Our Case Number: ABP-316272-23

Re: Bus Connects Templeogue/Rathfarnham to City Centre Core Bus Corridor Scheme
Templeogue/Rathfarnham to City Centre

**BusConnects Dublin Templeogue / Rathfarnham to City Centre CBC
 Submission on Planning Application in relation to the Proposed Scheme
 Objection to proposed Compulsory Purchase Orders
 Rathfarnham Castle Park
 Entrance to Rathfarnham Wood Estate**

Fig 14.5 – Regional Aquifers:

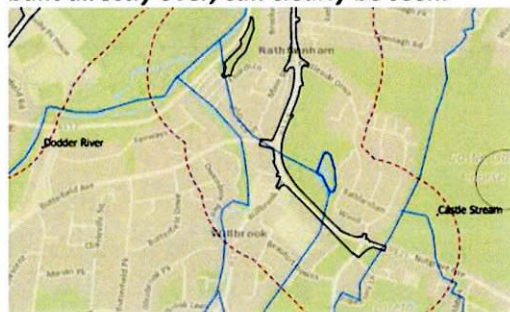
We cannot understand how the watercourse and pond in the Park have been missed for the purposes of the environmental surveys, given that the pond and the watercourse into and out of it can clearly be seen in **Fig 14.5 – Regional Aquifers** – which shows all of the rivers of Dublin marked in blue:

Similarly, in **Fig 14.13 – Aquifers**, the watercourse and pond (shown in outline) and where it runs under Grange Road in two separate locations, and would therefore be built directly over, can clearly be seen:

Close up view of Fig 13.1 – Surfacewater study area – showing no watercourse marked beside RCP although it is an open watercourse just inside the RCP wall where it will be directly built over. This is despite the fact that the maps at Fig 14.5 and Fig 14.13 clearly show the Glin River and duck pond.

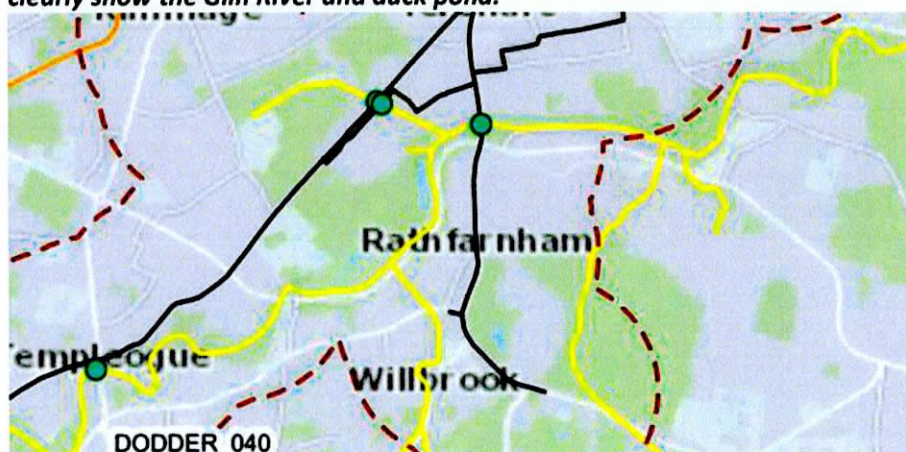
Yet when it comes to the actual environmental study areas, the Glin River and duck pond are not included. They have clearly not been evaluated or even considered. We cannot understand this glaring omission and clear breach of the Water Framework Directive.

Image 2.14 from Chapter 2 of the EIAR showing minimal impact from Grange Road to Rathfarnham Road / Fergus Road:

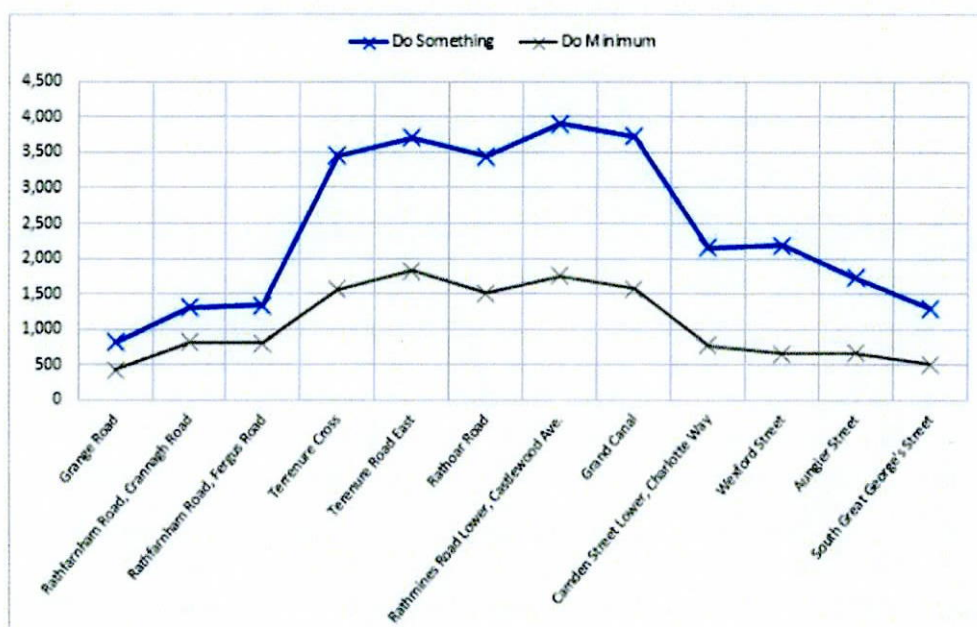
The projections show that the proposed reductions in journey time due to BusConnects will be minimal. Image 2.14 in Chapter 2 of the EIAR shows that the BusConnects scheme would have a far lesser impact around Rathfarnham than it would at other areas in any event.

Google Earth Screenshots showing the width of Grange Road is in excess of 15 metres:

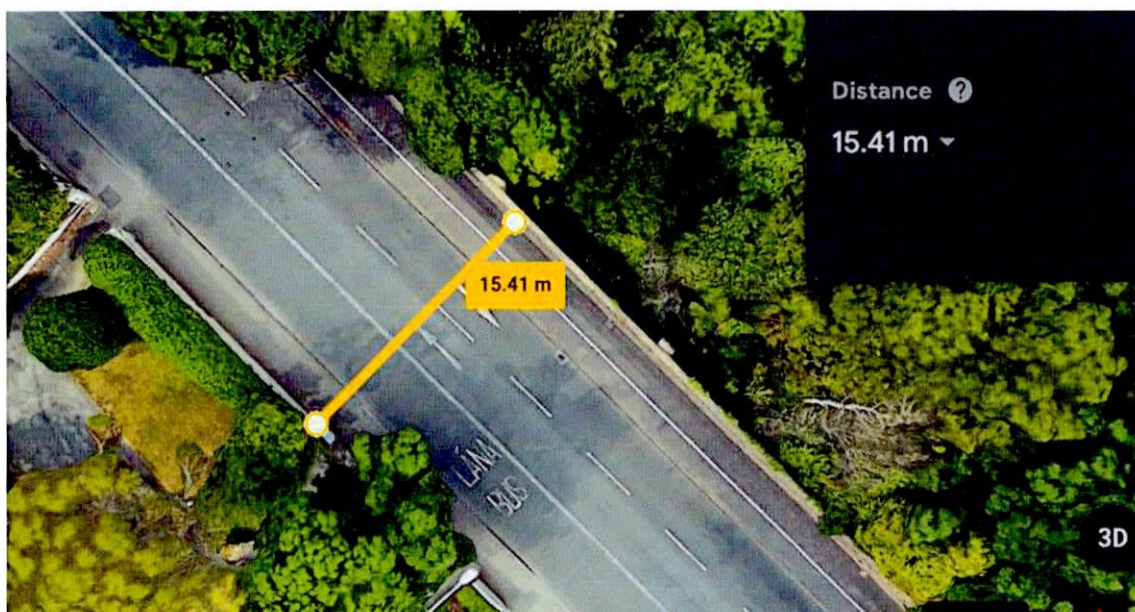
Separate to the issue of an outbound bus lane alongside the Park is the issue of the use to which the remainder of the land proposed to be acquired would be put. An area of **up to 10 metres in width**, as is stated in the Scheme documents, appears to us to be totally excessive and unnecessary, given the width of the existing road. The current road is in excess of 15 metres wide at all of the points which I have checked, as can be seen from the Google Earth screenshots below.

There is currently a footpath of c. 1.7m and a cycle path of c. 1.4m running directly alongside the Park, so that there is not a massive divergence there from the proposed widths.

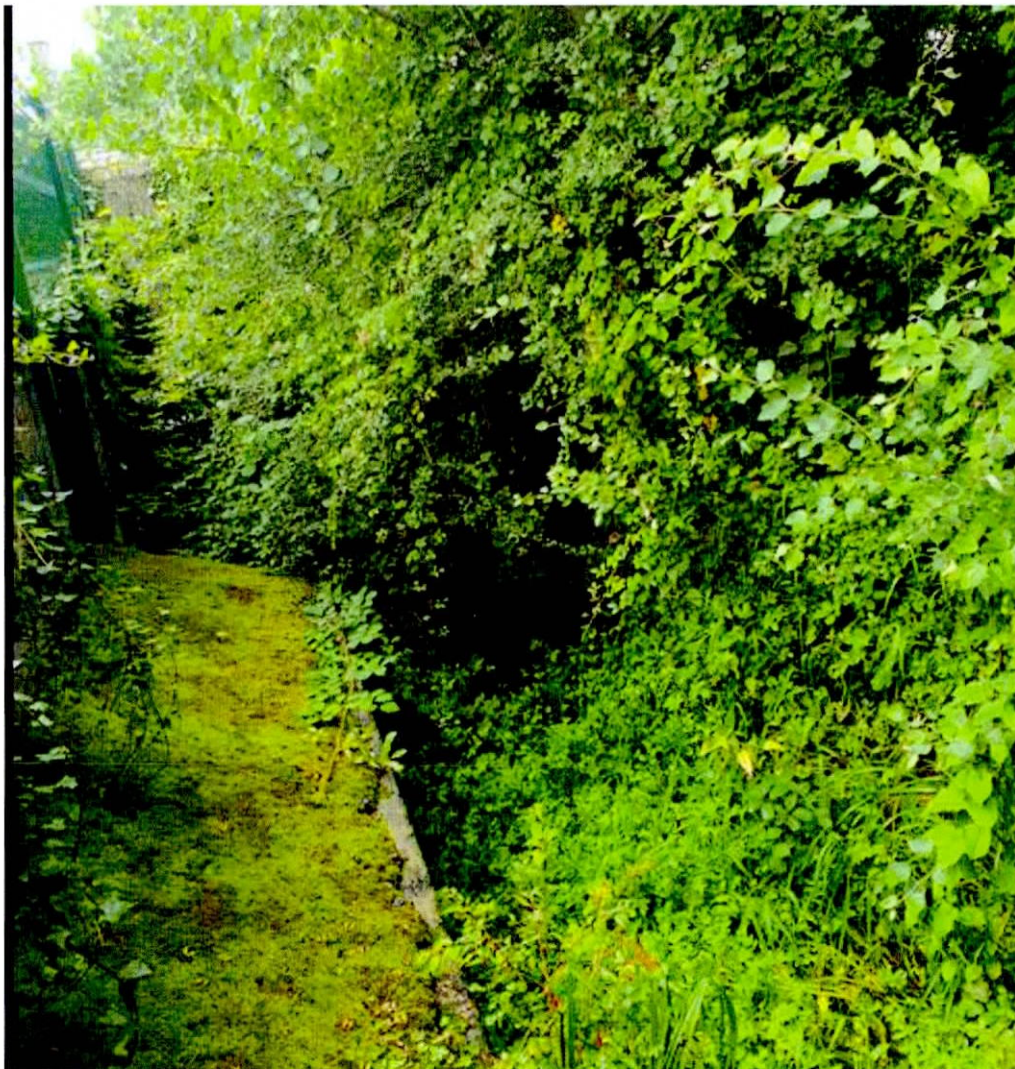
“The watercourses surveyed along the Rathfarnham Section of the Proposed Scheme were the River Dodder (Dodder_050) and the Grand Canal.”

This completely omits to consider the Glin River (also known as the Whitechurch Stream or Landy’s Millrace), which flows into the Park where it bounds the Grange Road close to St Mary’s BNS and

flows out again under the Grange Road beside Butterfield Avenue. The Glin River and the duck pond in the Park can be clearly seen in Figs 14.5 and 14.13.

This watercourse is directly impacted by the proposals as it runs under Grange Road where the Park's south-eastern boundary is located. It would be directly built over, should the plans proceed, as the road is proposed to be widened permanently to the extent of c. 6 metres at that precise location.

Fig 12.1.3. - Ecological Study Areas: Aquatic and Riparian Survey Site:

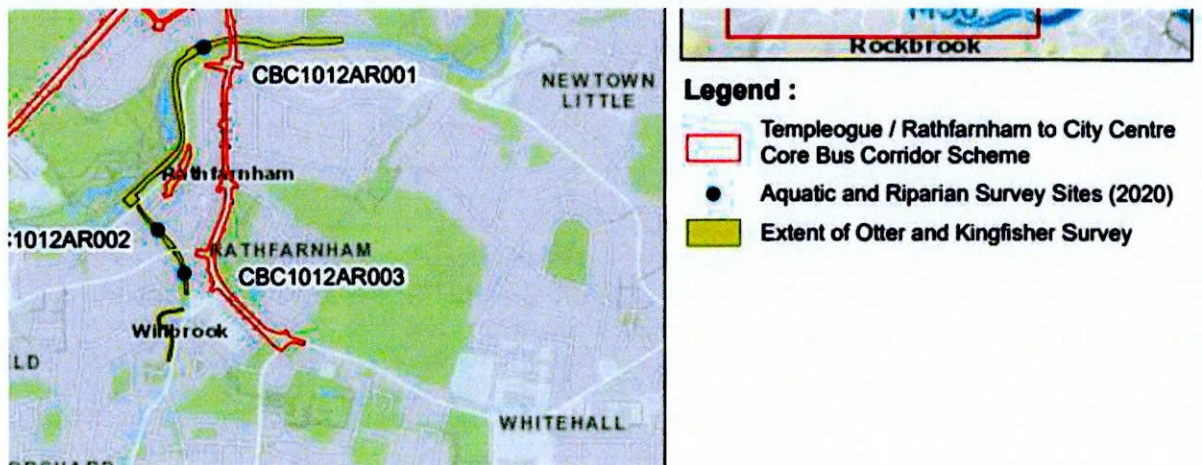
“During early iterations of the Proposed Scheme, the desk study identified three sites where water bodies may be subject to significant disturbance as a consequence of the Proposed Scheme. One of these sites is located at the proposed crossing point on the River Dodder, connecting Dodder View Road to Rathdown Park. The other survey locations are at the proposed crossing points of the Owenadoher River, in the vicinity of Butterfield Avenue, Rathfarnham, at Woodview Cottages and Saint Mary’s Avenue.”

It is clear that neither the Glin River nor the pond were surveyed for otters or kingfishers. This is despite the fact that a kingfisher has been spotted in the Park, most recently on 23/7/23 and the Glin River / Whitechurch Stream is a known otter habitat.

Fig 14.5 – Regional Aquifers - Again, the River Glin and pond can clearly be seen in this extract from Fig 14.5:

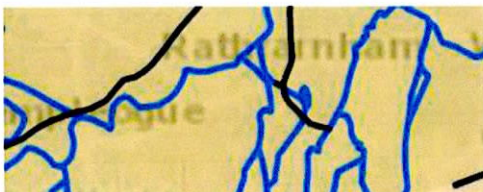
In any event, as stated already, the River Glin and RCP pond are actually already clearly shown in *Fig 14.5 – Regional Aquifers* – yet they were not taken into account for the purposes of hydrological, hydrogeological or other environmental assessments.

They are also shown in Fig 14.13 – Aquifers – which show the outline of the pond and the watercourse flowing into and out of the Park:

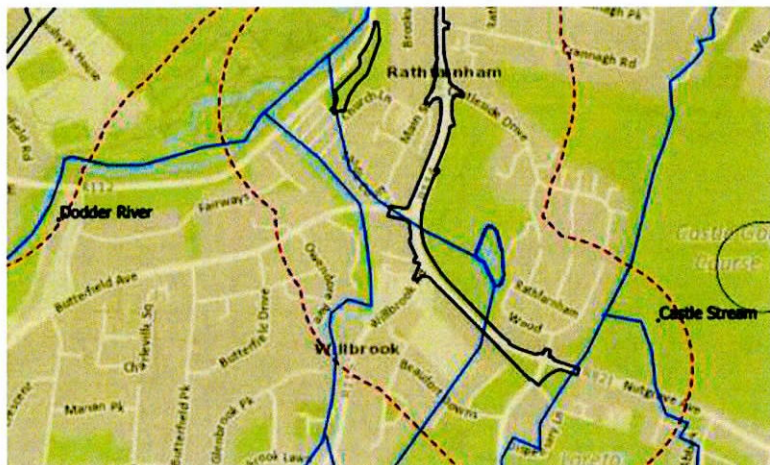
- c. Complete omission of Rathfarnham Castle Park itself from the Hydrogeology summary report; misunderstanding of significance of the Glin River / Whitechurch Stream in the Hydrogeology summary report.**

Fig 12.1.2 Ecological Study Areas: Wintering Bird Transect Route – RCP was not studied:

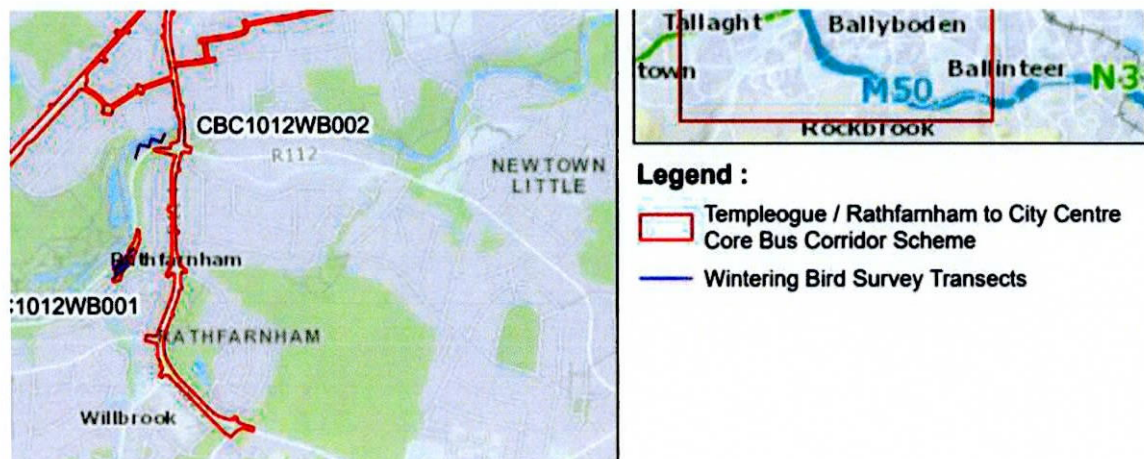
This omission can also be seen from Fig 12.1.2 Ecological Study Areas: Wintering Bird Transect Route - the wintering bird survey transects did not include RCP.
